CITY OF ALBUQUERQUE

**Re: Fiesta Subaru
7100 Lomas Blvd NE
Traffic Circulation Layout
Engineer's Stamp 02-21-2022 (K18-D108A)**

Based upon the information provided in your submittal received 03-01-2022, the above referenced plan cannot be approved for Building Permit until the following comments are addressed:

A1 SITE PLAN
1" = 20'-0"

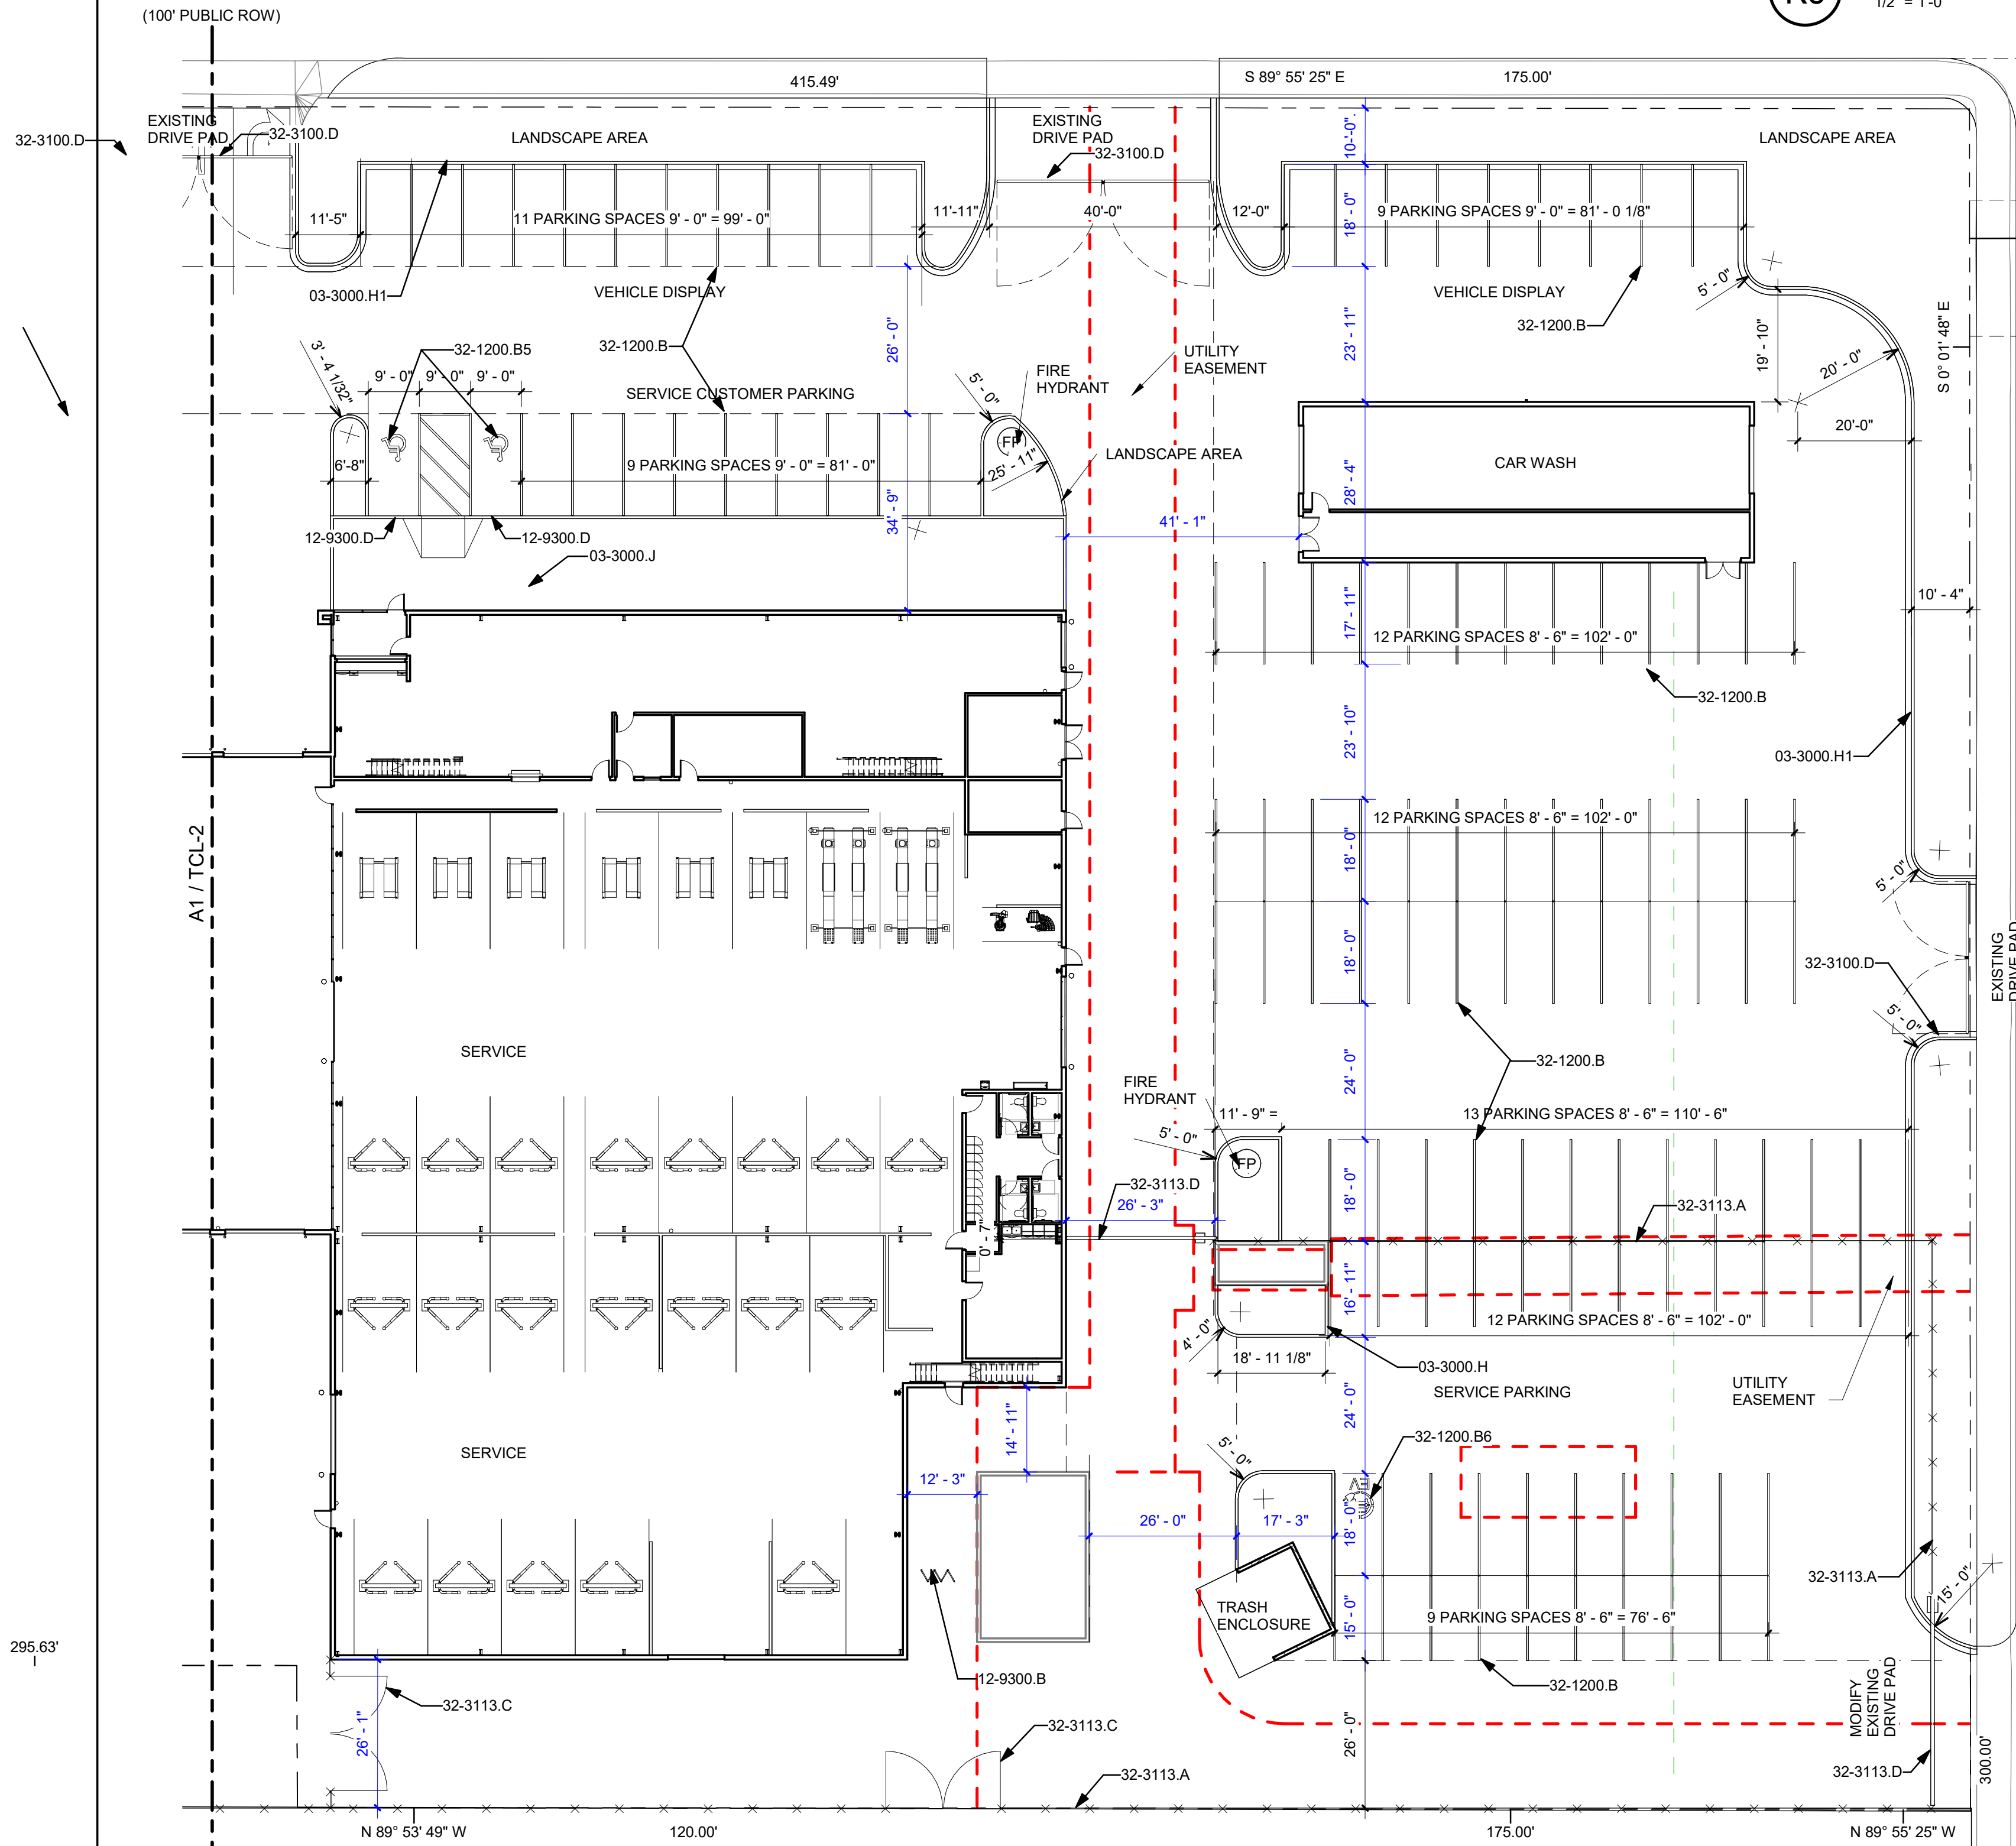
27. Chamas st: Show the clear sight triangle and add the following note to the plan:
"Landscaping and signage will not interfere with clear sight requirements. Therefore, signs, walls, trees, and shrubbery between 3 and 8 feet tall (as measured from the gutter pan) will not be acceptable in the clear sight triangle.

28. Chama/Lomas proposed striping:
 - Lane width for ingress needs to be provided.
 - Proposed lane widths need to be 11 ft minimum width and specify solid strip on striping notes.
